Addendum 78 – UN Regulation No. 79

Revision 4 - Amendment 2

Supplement 2 to the 03 series of amendments – Date of entry into force: 25 September 2020

Uniform provisions concerning the approval of vehicles with regard to steering equipment

5.6.4.6.4.1. Automatic initiation of the lane change manoeuvre

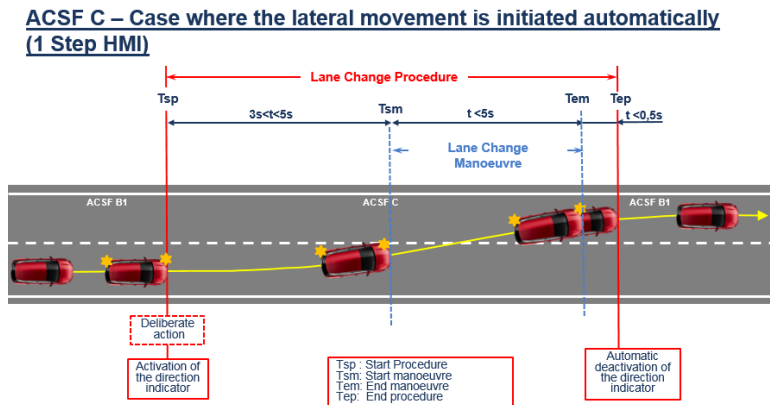
In case of an automatic initiation the lane change manoeuvre shall commence between 3.0 seconds and 5.0 seconds after the manual activation of the procedure as described in paragraph 5.6.4.6.2. and shown in the Figure below.

5.6.4.6.4.2. Initiation of the lane change manoeuvre by a second deliberate action

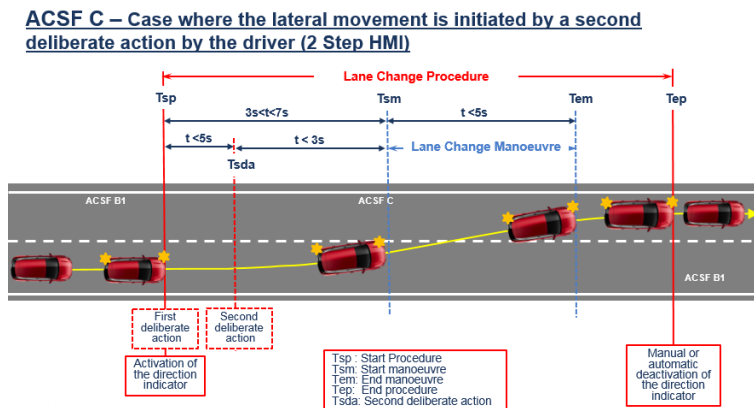
In case of an initiation by a second deliberate action the lane change manoeuvre shall commence between 3.0 and 7.0 seconds after the manual activation of the procedure as described in paragraph 5.6.4.6.2.

Additionally, the lane change manoeuvre shall commence at the latest 3.0 seconds after the second deliberate action as shown in the Figure below.
